Preconstruction Conference- Contractor's Questions

BID FORM- GREENLAWN DRIVE STREETScape

GREENLAWN DRIVE (S-296)
LANDSCAPE PLANS

SHEET LA 2 SCALE: 1" = 20'

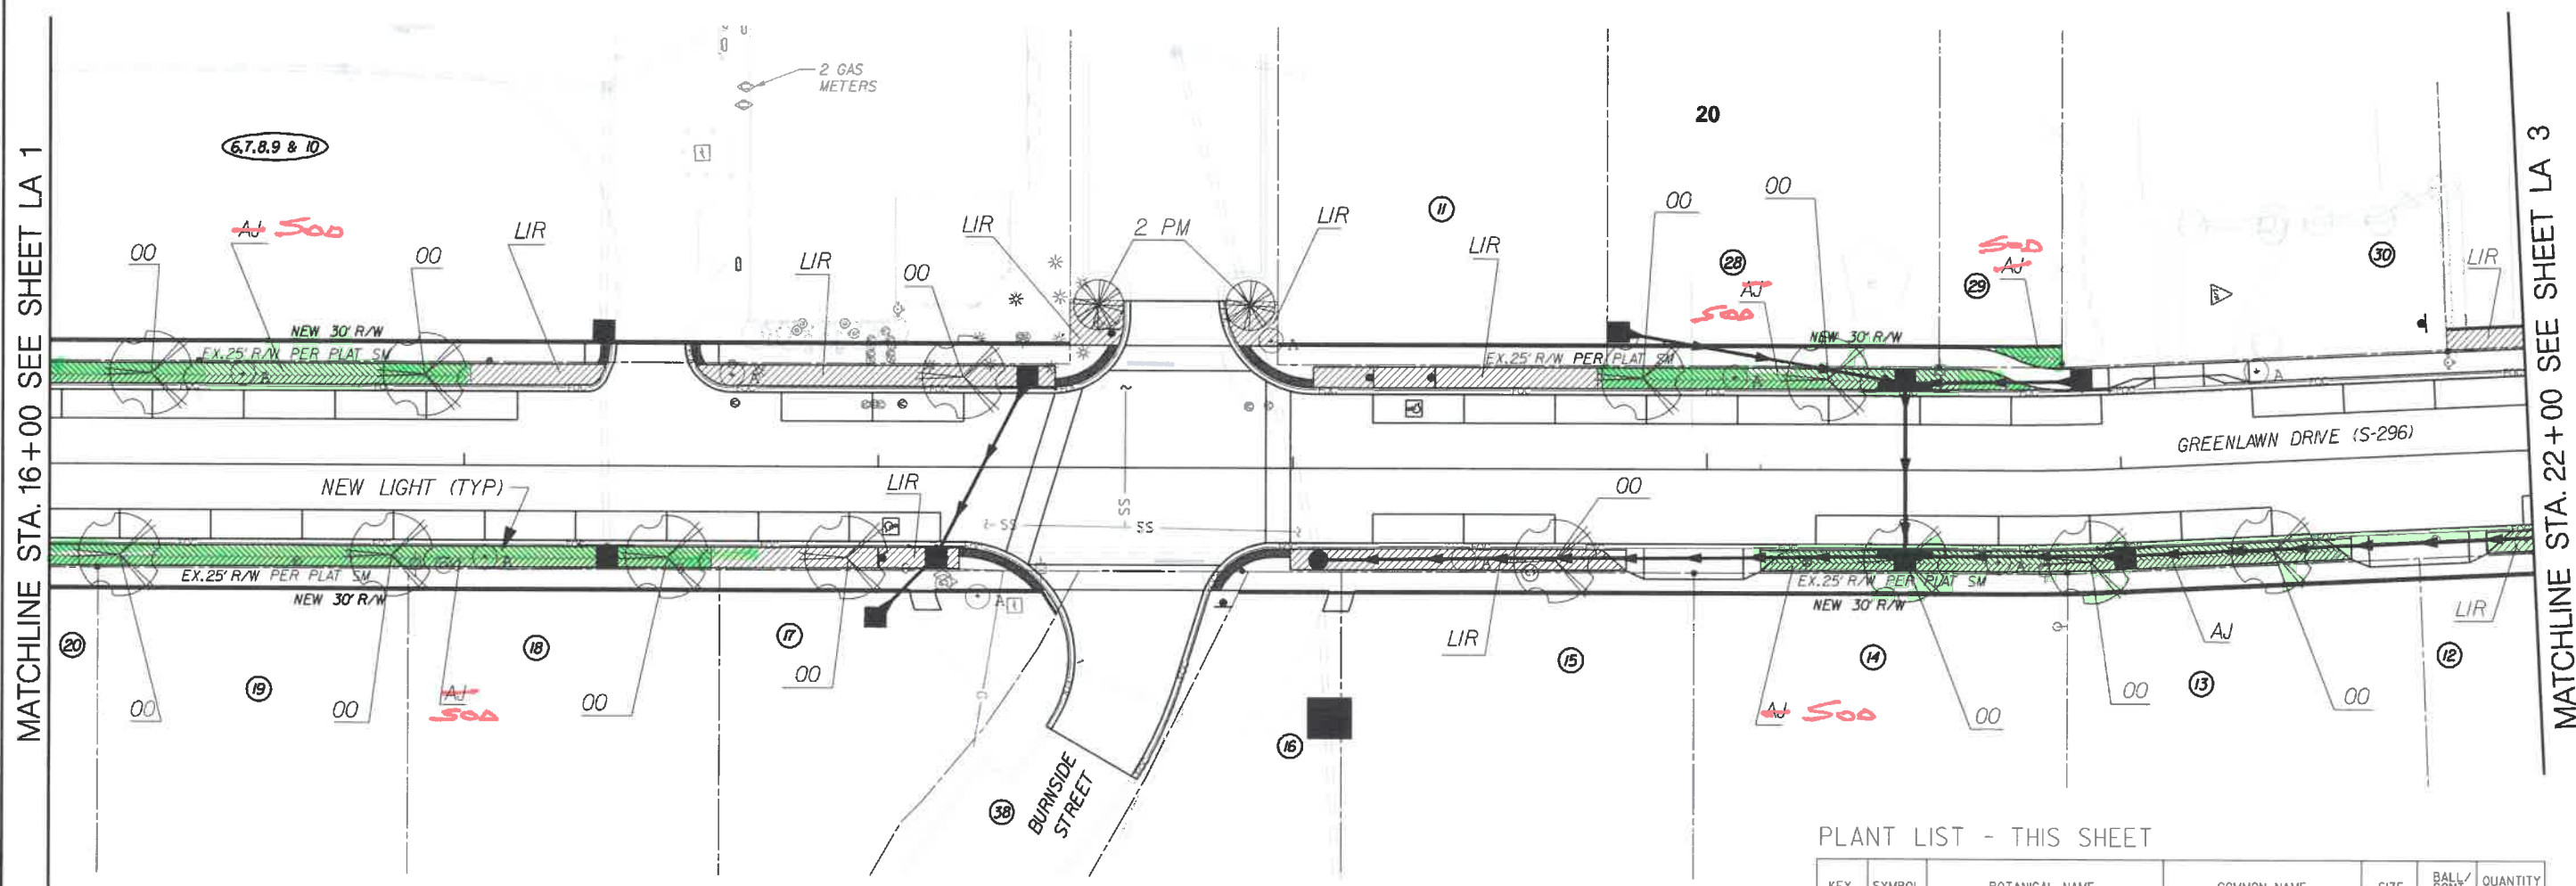
Please note: With regard to the Landscaping Plans in the Contract Drawings, the Owner has enacted some alterations to the landscaping plans. These changes are reflected in the documents being forwarded as part of this addendum.

Below is a narrative of the changes being made. As part of this addendum, we have included mark-ups (in color) of the landscaping sheets and an updated Schedule of Values -Part 1 and Part 2. The updated Schedules of Values provided with addendum shall be used for the bid submittal in lieu of those in the “original” Contract Documents (Section 1.8-Schedule of Values – Part 1 & Part 2). The summary of landscaping changes is as follows:

- Remove bid item of Asiatic Jasmine from Schedules of value
- Replace all Overcup Oaks in bid with Southern Live Oaks
- Replace Sabal Palms in bid with Cabbage Tree Palm (Palmetto)
- Centipede Sod for all areas highlighted in green (Planting areas that were to have Asiatic Jasmine)
- Double -Shredded Hardwood Mulch quantities added to Schedule of Values (Sec 1.8) Pt 1 & Pt 2
- Contactor to revise quantities on sheet L4 to reflect above changes
